# Access Compliance Report Public Rights-of-Way (Curb Ramps)

| Intersection ID: 10247 | Main Street: BURTON_ST  | Cross Street: WHISNANT_ST | Location: NE                                    |
| ADA ID: CD44BAAFDD82   | Ramp Type: Combination2 | Initial Pass/Fail: Fail   | Overall Compliance: No<br>Severity Score: 36.25 |

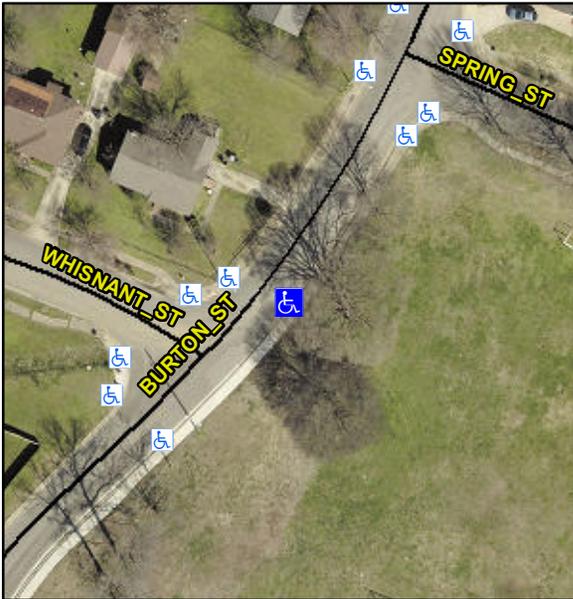
Surveyor Notes:

**RT RP < 5%**

PROW/ADA:

**Not Found, R304.5.1, R304.5.1, R304.5.3**

Possible Solutions:

**Remove & Replace Entire Ramp.**
